QUESTIONS AND ANSWERS FOR THE RFP #1000231048

Overview map for the reforestation project

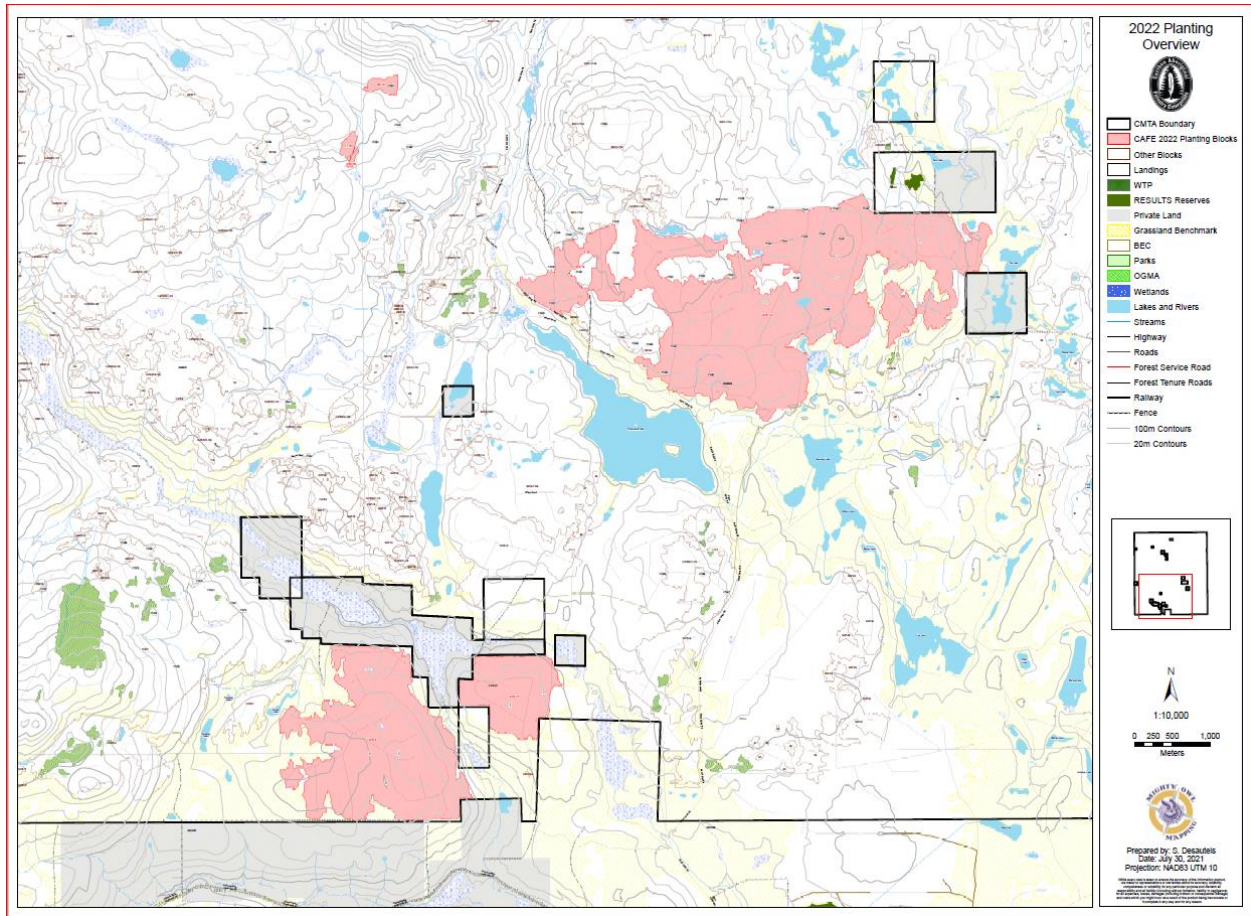
Q&A#	QUESTIONS AND ANSWERS																												
Q2	Can Indigenous Services Canada provides an overview map for the reforestation project?																												
A2	 CAFE_2122_PlantOverview_20210730.pdf See attachment below																												
Q3	Is it possible for the contractor to set up a work camp to accommodate workers in the Spring 2021?																												
A3	Indigenous Services Canada cannot authorize the successful solicitor to set up camp within lot 7741. Permission to setup camp can be granted by the Department of National Defense (DND). In recent years (2018, 2019, 2020) contractor successfully obtained permission from DND to setup reforestation camp at the old airstrip along the Stack Valley Road.																												
Q4	What is the earliest start date for the reforestation in the spring 2022.																												
A4	Historically, reforestation activities have started the last of April each Spring.																												
Q5	What is the block priority order?																												
A5
